WPD4 - Retrofitting Camera for Night Vision System (Stop Delivery)

Model Line: **911 (992)**

Equipment: **Night View Assist (M No. 9R1)**

Concerns: **Night vision system camera**

Installation position of camera for night vision system

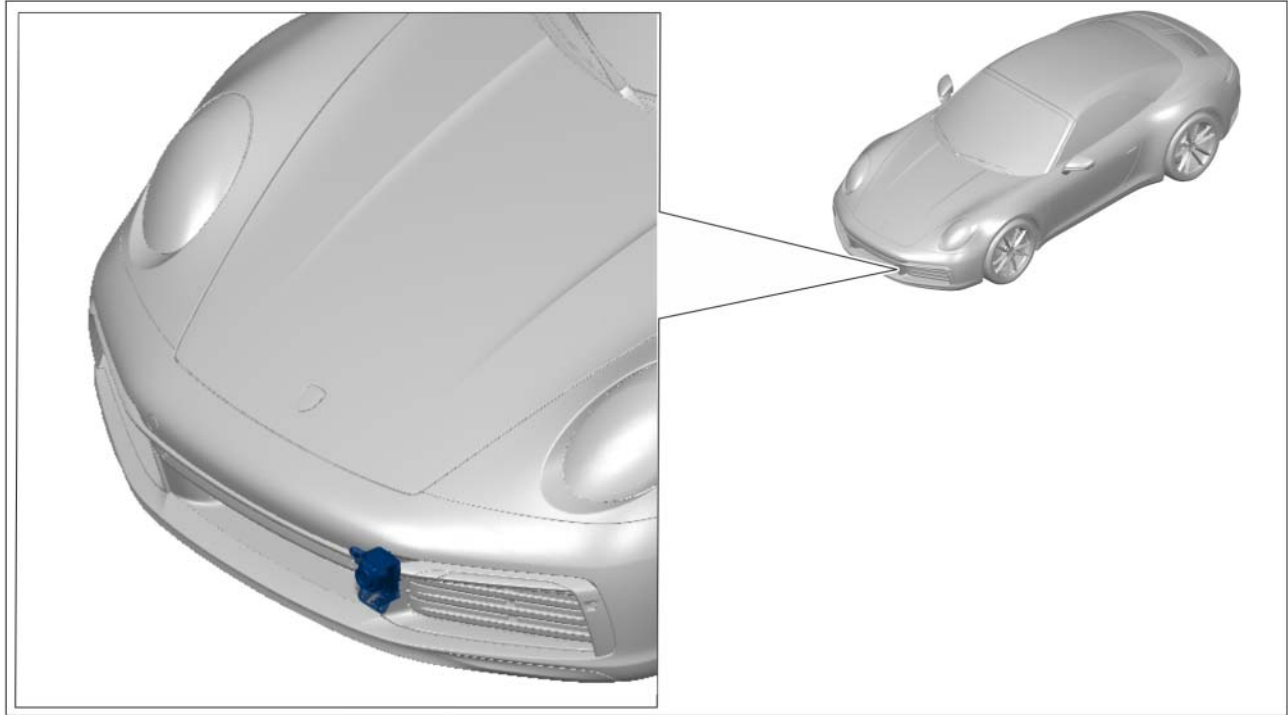
Cause: **Due to worldwide semiconductor shortages experienced by some suppliers, the affected vehicles were built without a night vision camera.**
As a result, the night vision system is not available.

– **(Retrofitting)** camera for night vision system

Action: Retrofit camera for night vision system.

Please note that the connection line for the night vision camera is secured to the holder of the night vision camera with a tie-wrap and sealed with a dummy plug. Carefully remove the tie-wrap and dummy plug before installing the night vision camera.

Work Procedure: 1 Retrofit camera for night vision system.
For this, see: ⇒ *Workshop Manual '908019 Removing and installing infrared camera'*
